File Number  
PDC 06-003

Application Type  
Planned Development Rezoning

## STAFF REPORT

Re: PDC 06-003 -- Revised Plans -- Proposed Lowe's South San Jose

<p>LOWIE'S®</p>
<p>EXTERIOR ELEVATIONS</p>	<p>LOWIE'S OF SOUTH SAN JOSE SAN JOSE, CALIFORNIA</p>
<p>DATE: 03.01.08 DRAWN BY: [illegible] CHECKED BY: [illegible] DATE: [illegible] DRAWING NUMBER: A-5</p>	<p>03.01.08</p>

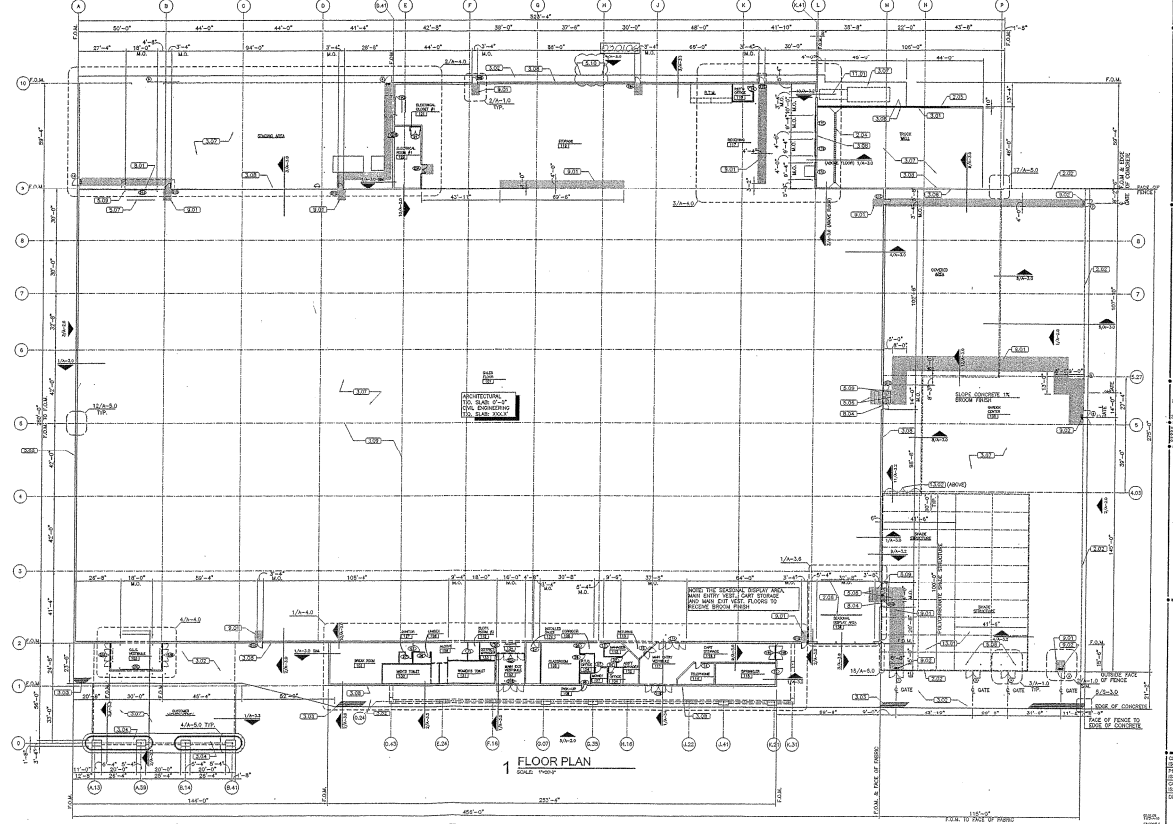
- a. Left Elevation – (Sheet A-5) The proposed blank wall is not desirable for a busy street like Cottle Road. Make this façade more interesting by including features similar to those used on the front elevation (i.e., pilasters, columns, canopy, etc.). Another possible feature might be colorful metal panels which evoke Building 25.

- b. Right Elevation – (Sheet A-5) A 20'-0" tall security fence facing a park and high density housing is not compatible with the proposed high-density housing and park planned across the street. A design which incorporates greenhouse-type features might make this elevation seem less like a secured compound and more like a garden center. See attached photo of Target's garden center located at the San Jose Market Center. Note the use of different materials, storefront windows, columns and metal fences all of which make the building elevation look a higher quality and more interesting.
